HISTORIC AND DESIGN REVIEW COMMISSION

May 01, 2019

HDRC CASE NO: 2019-100
ADDRESS: 306 E PARK AVE
310 E PARK AVE
LEGAL DESCRIPTION: NCB 392 BLK 30 LOT 2 & S 17.71 FT OF 1 NCB 392
BLK 30 LOT 3&4
ZONING: IDZ,HS
CITY COUNCIL DIST.: 1
DISTRICT: Tobin Hill Historic District
APPLICANT: Patrick Christensen
OWNER: Imagine Built Homes LLC
TYPE OF WORK: Construction of eight detached single family townhomes
APPLICATION RECEIVED: March 29, 2019
60-DAY REVIEW: May 28, 2019
CASE MANAGER: Stephanie Phillips
REQUEST:

The applicant is requesting a Certificate of Appropriateness for approval to construct eight residential townhomes on the vacant lots addressed 306 and 310 E Park Ave. Two of the townhomes will be 2-stories and the remaining six will be 3-stories.

E. Park Street Elevation view to South

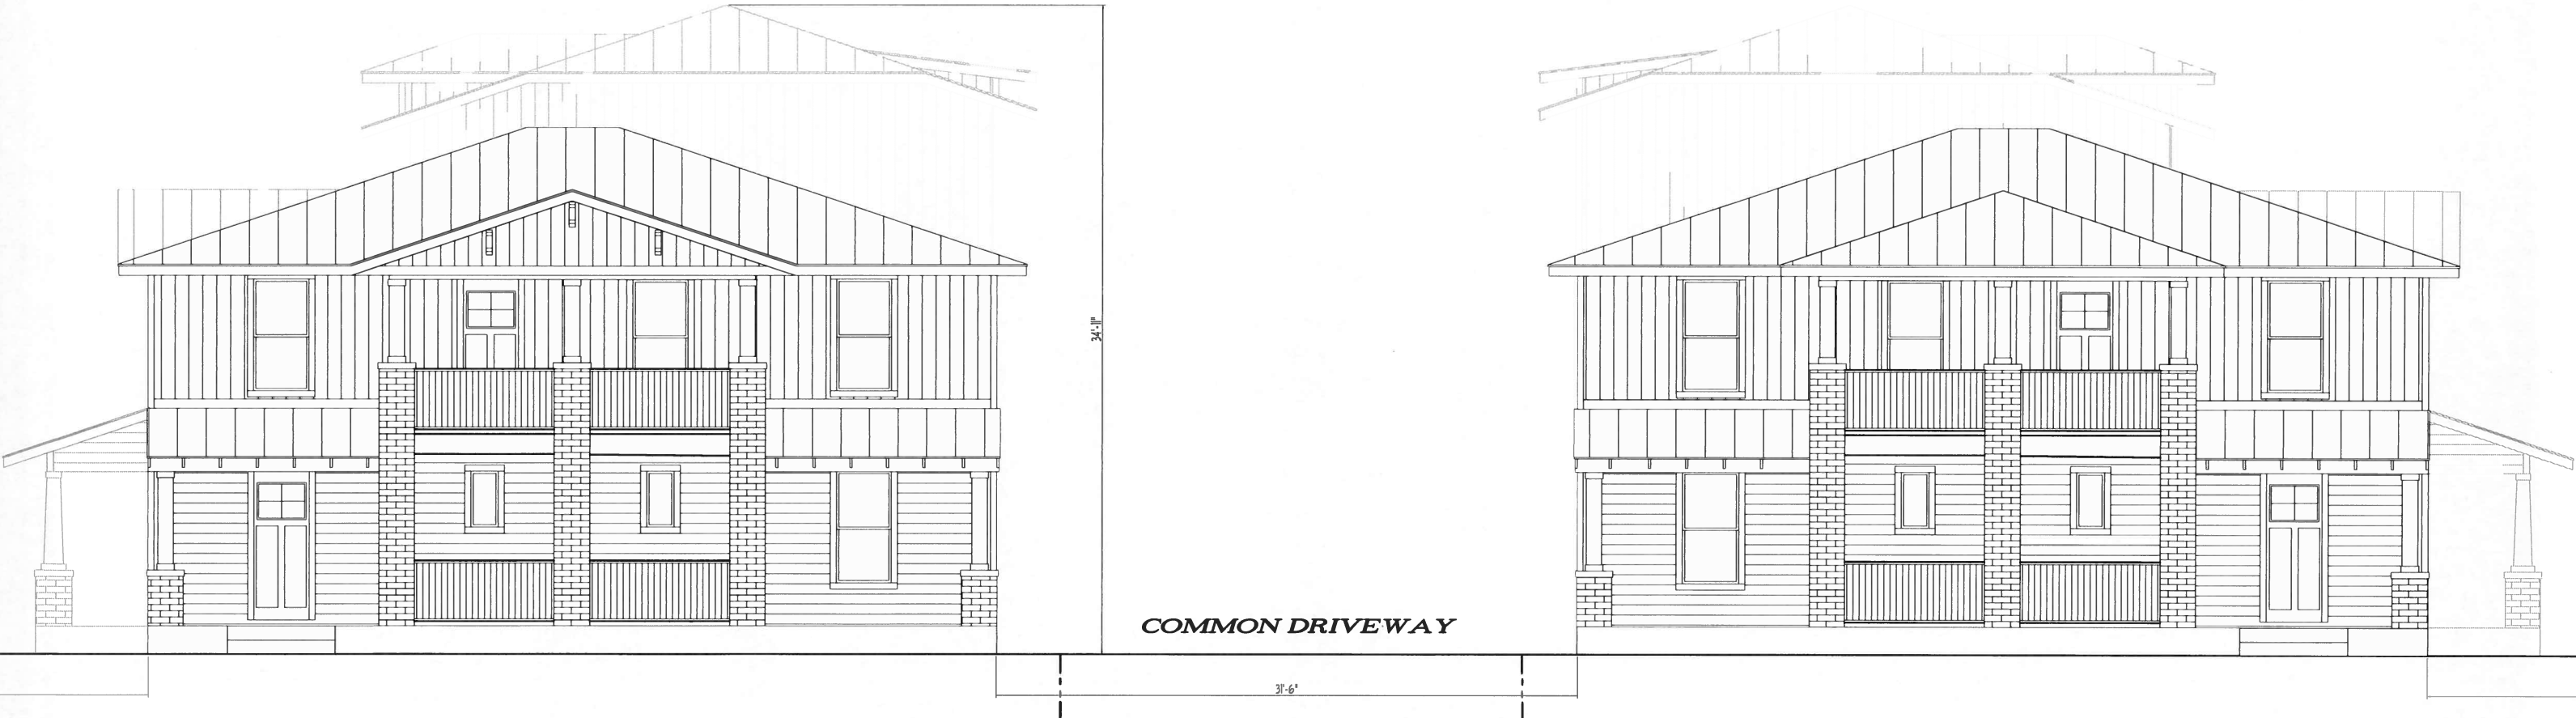
- e. ORIENTATION & ENTRANCES – The applicant has proposed to orient the two buildings fronting E Park Ave towards the street. The other six buildings will be oriented either towards McCullough Ave or towards the neighboring structures to the east. All buildings will include garages and vehicular access from a common drive in the middle of the site. According to the Guidelines for New Construction, front façades should be oriented to be consistent with those historically found along the street frontage. Typically, historic entrances are oriented towards the primary street. This is true for this particular block of E Park Ave. Staff finds the orientation and entrances of the overall proposal to be departure from typical development patterns in the vicinity. Additionally, although four of the structures are facing west towards McCullough, a separately-owned vacant lot is located between this proposed development and McCullough. While the lot is currently vacant, the four structures facing this direction may face the rear of a structure in the future, which deviates from the historic development pattern. Staff also finds the orientation and entrance configuration of the front two buildings along E Park Ave to be inconsistent with the duplex precedents in the district. Staff finds that the porch design and fenestration of these structures should be modified to include two doors along E Park Ave and design detailing that responds to existing precedents in the district.

- j. **WINDOW & DOOR OPENINGS** – According to the Historic Design Guidelines for New Construction, window openings with a similar proportion of wall to window, as compared to nearby historic facades, should be incorporated. Similarity is defined by windows that are no larger than 25% in size and vary no more than 10% in height to width ratio from adjacent historic facades. The applicant has proposed several window and door openings that generally feature sizes that are found on historic structures. However, the applicant has also proposed window openings that are not consistent with the OHP Window Policy Document or historic fenestration precedents in the district, particularly small square openings with no divided lites. According to the OHP Window Policy Document, wood windows are most appropriate. Windows should also maintain traditional dimensions and profiles, and false dividing lites are not encouraged. Each window should be inset at least two (2) inches within walls to ensure that a proper façade depth is maintained. All windows should feature traditional appearance and feature traditional trim and sill details. As noted in finding e, the fenestration of the two front structures should be modified to include two doors along E Park Ave.

- i. That the applicant reduces the width of the two front buildings facing Park Ave and incorporates more consistent architectural features, including proportionate porch elements and a consistent solid to void relationship, to be more consistent with massing precedents in the district as noted in finding e, f, and i.

- ii. That the applicant reconfigures the front elevations to read as a traditional duplex to be more consistent with traditional orientation patterns and duplex street configurations in the district as noted in finding e.

306 & 310 E. Park

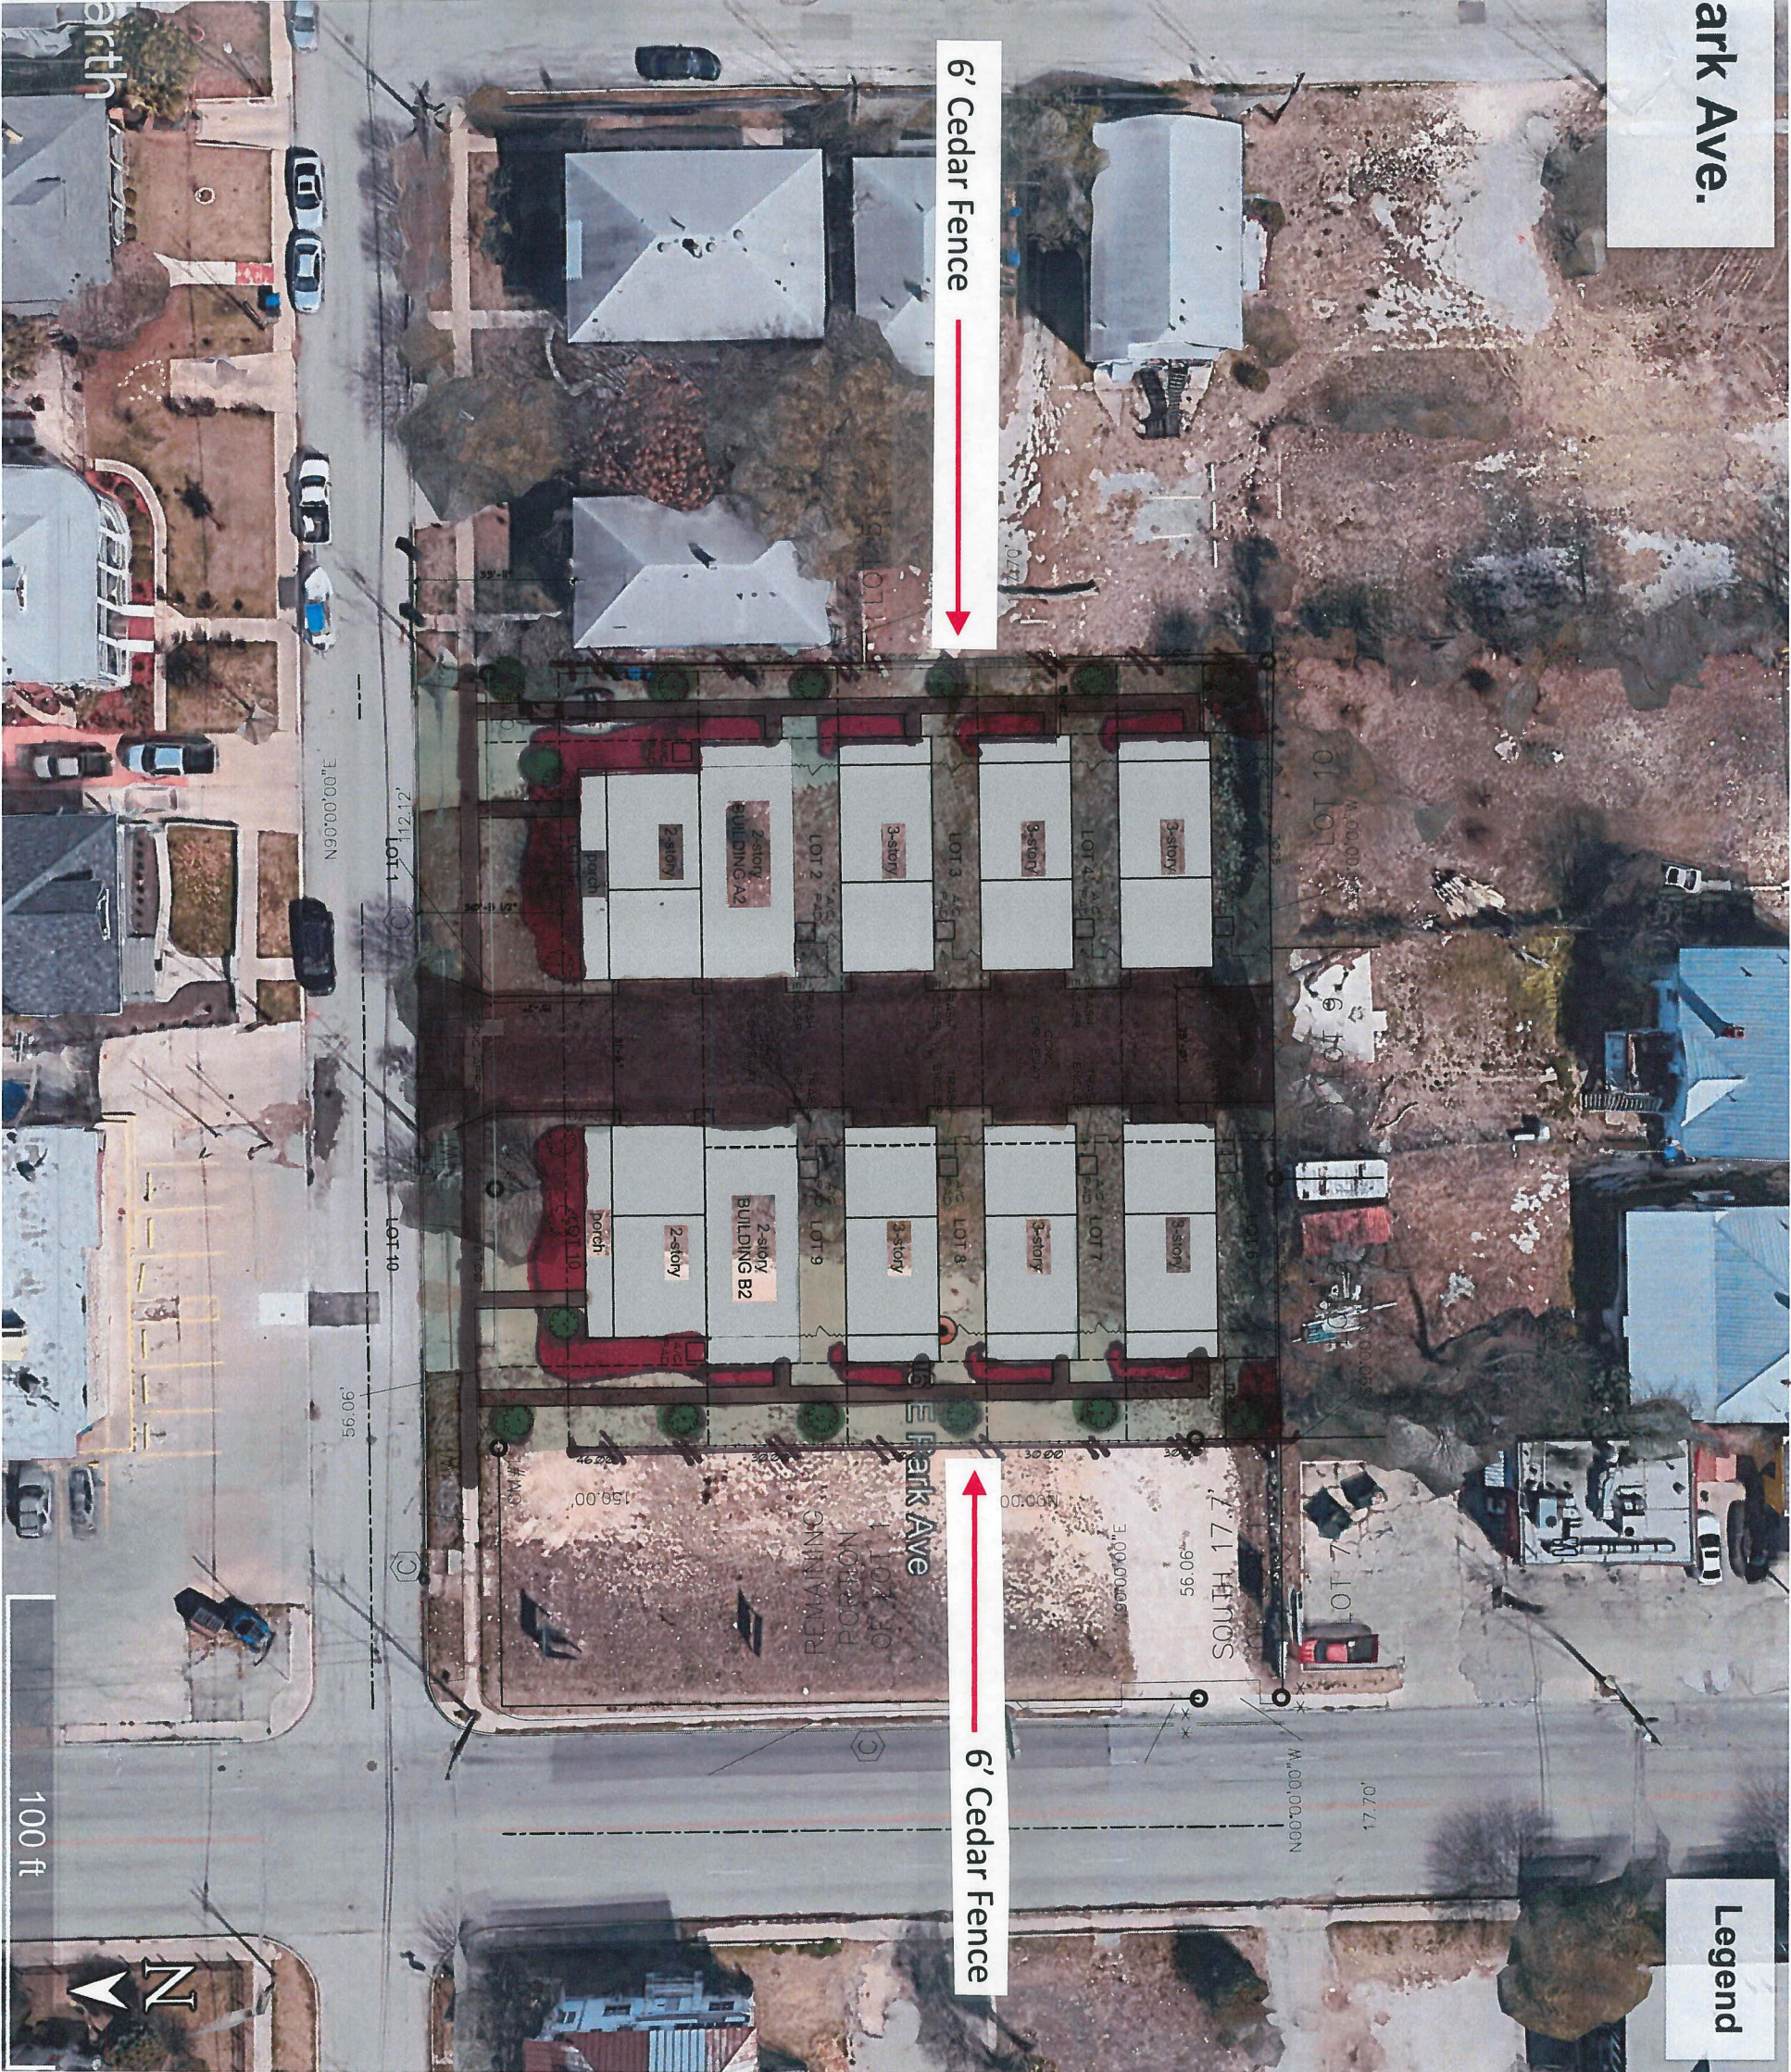
- o. **LANDSCAPING & FENCING** – The applicant has provided a landscaping and hardscaping plan that includes the

planting of several trees and the inclusion of several mulch planting beds. The plan also includes 6' wooden privacy fencing, which is generally eligible for administrative approval. Staff finds the proposal generally appropriate.

- p. **HARDSCAPING** – The applicant has proposed a 25' wide central driveway property accessible off E Park. The applicant has reduced this width from a previous proposal. While the central drive is not a predominant development pattern in the district, staff finds the reduction in width acceptable for the proposal.
